ADDENDUM #1

Hudson Dog Park

HUDSON, MASSACHUSETTS

June 02, 2025

SITE PREPARATION PLAN

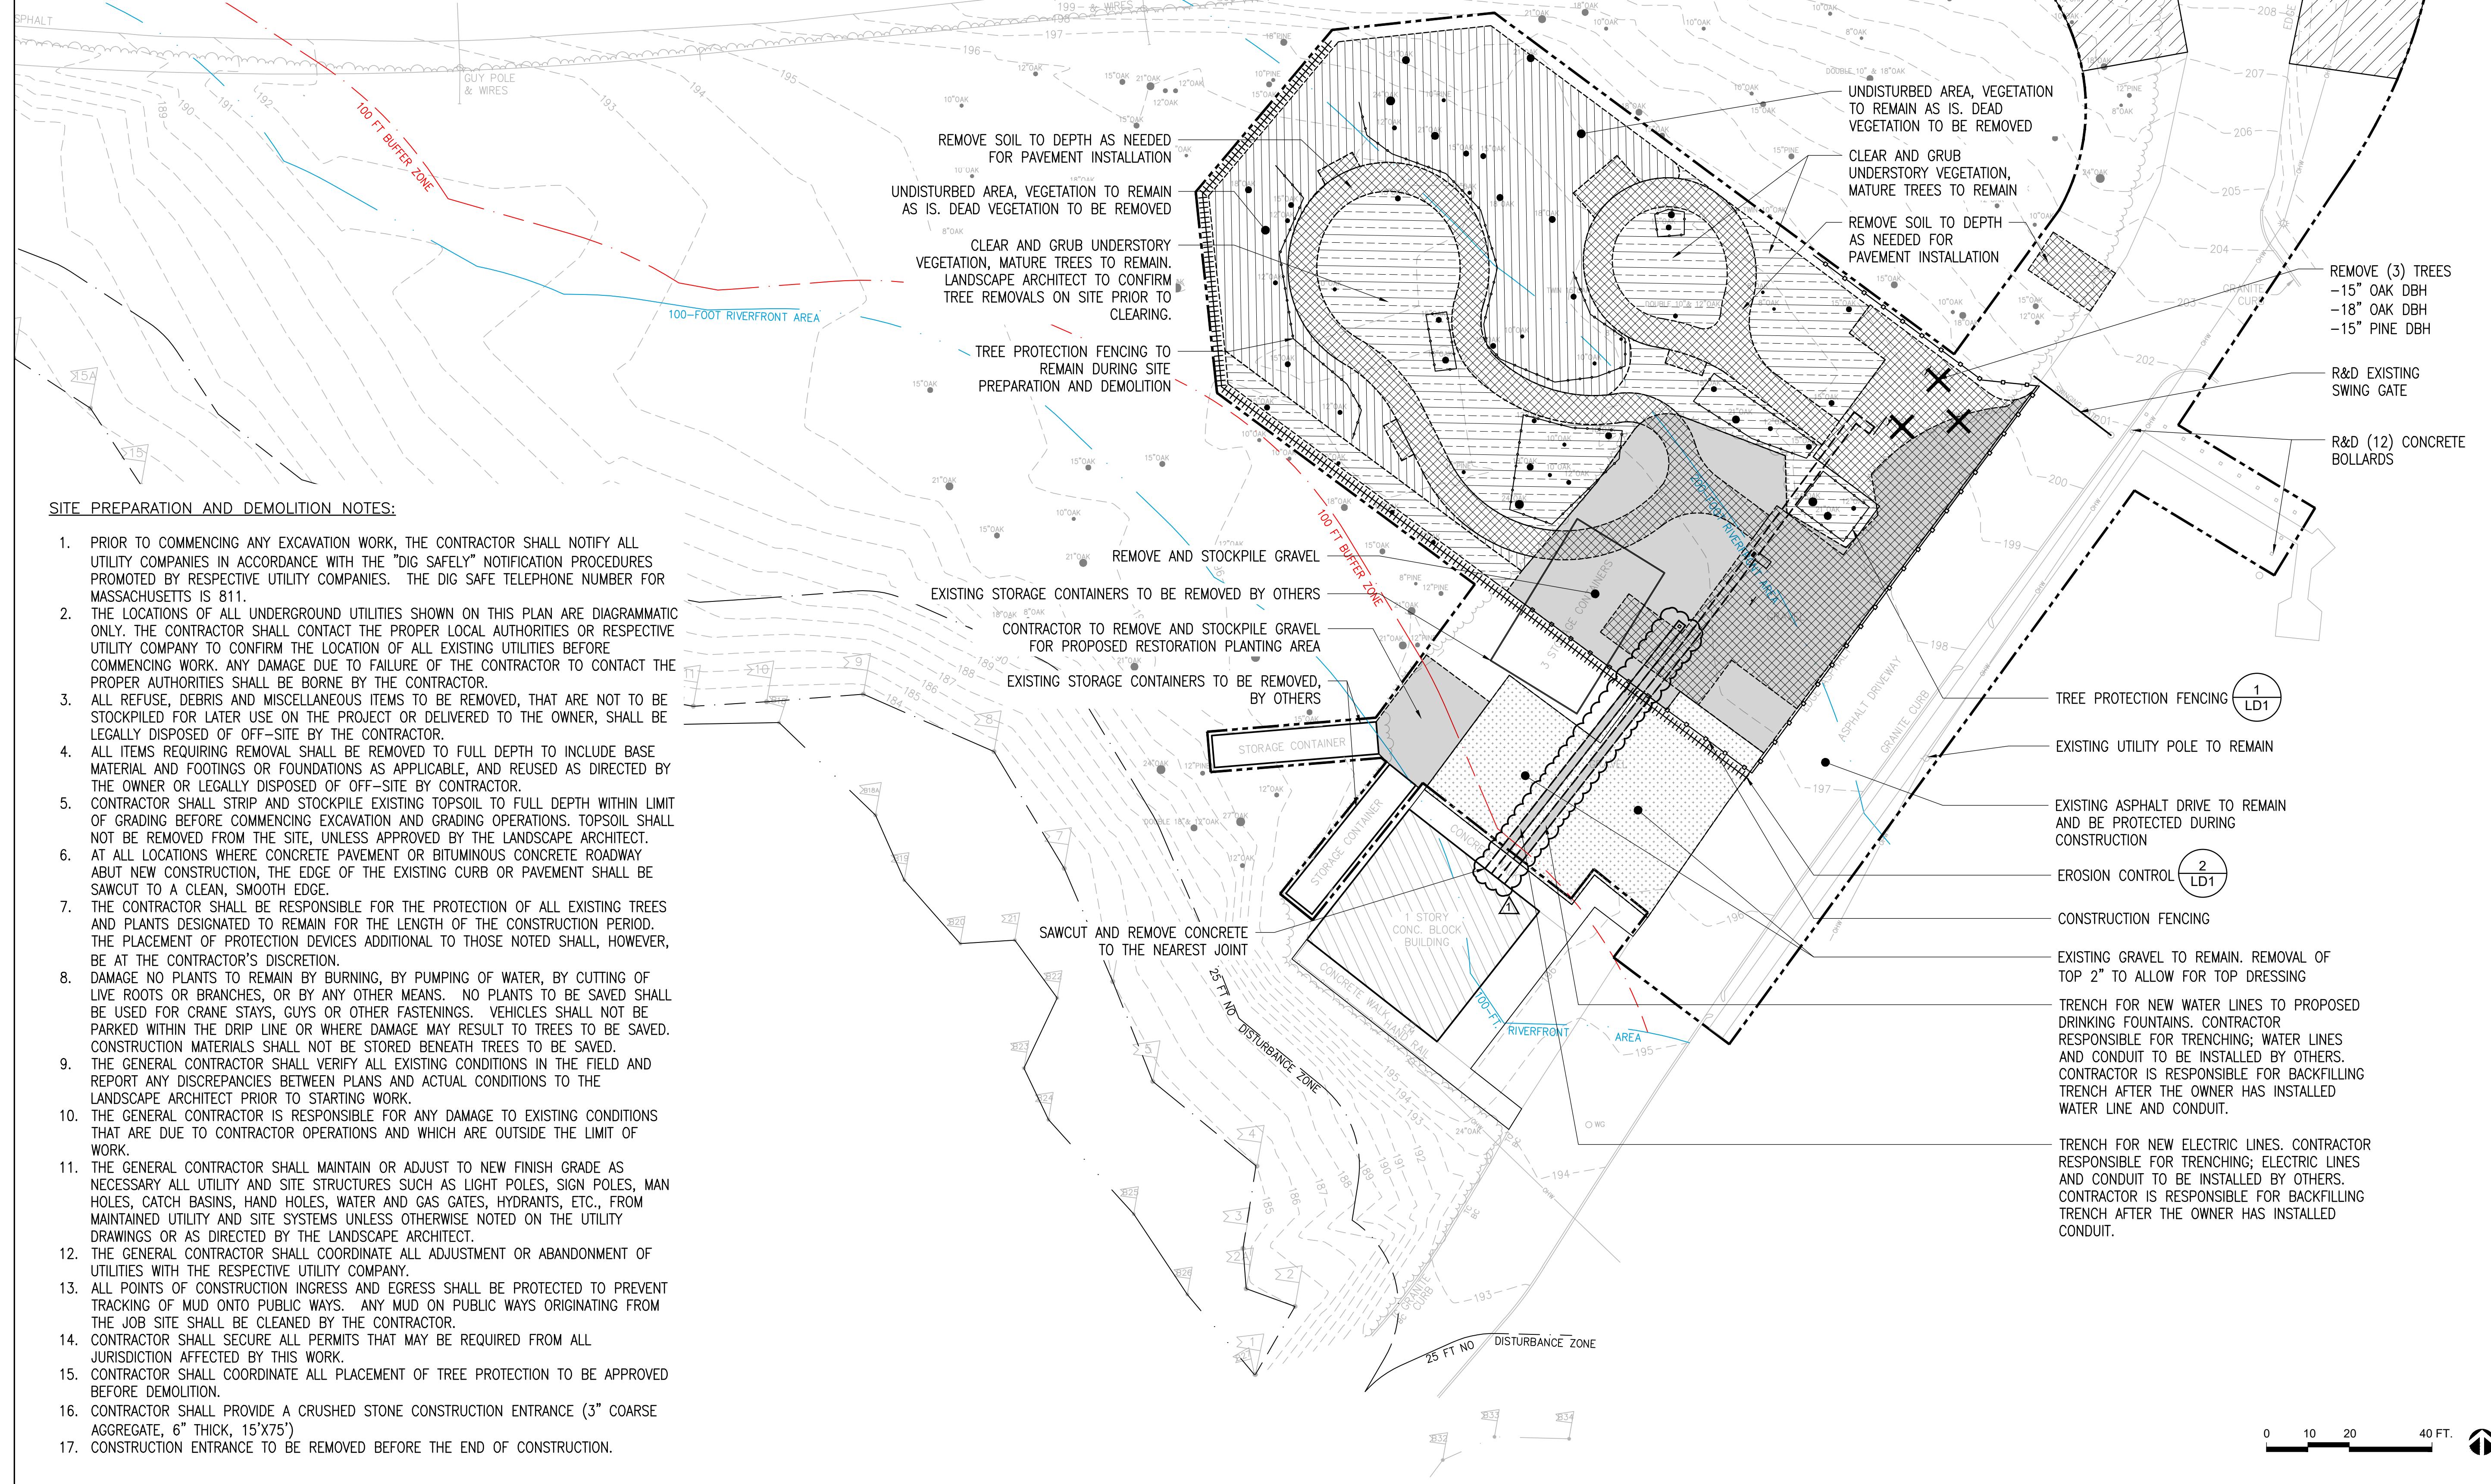
1.0 What is to be done with the Water Test Point?

2.0 Can you confirm the water and electric conduit can be in same trench?

10.0 What is the clearing scope along Main Street?

- Modification to Contract Drawing sheet SP1 & L2: Contractor to remove existing pedestal to well test point and install a new flush mounted test cover (provided by Contractor). Location to be verified in the field.

- Modification to Contract Drawing sheet SP1, L2, & LD1: Water and electrical conduit cannot be installed in the same trench as shown in the drawings and shall be in separate trenches. Trenches shall be separated by a minimum horizontal distance of 36”. Revised plans are attached to addendum #1.

- Clarification to Contract Drawing sheet SP1: There are (3) trees over 12" DBH and 1 overhanging limb at the park driveway entrance to be removed. All understory brush to be cut flush with grade in areas designated on the construction drawings. The Contractor is responsible for providing a police detail if tree work will impact the roadway.
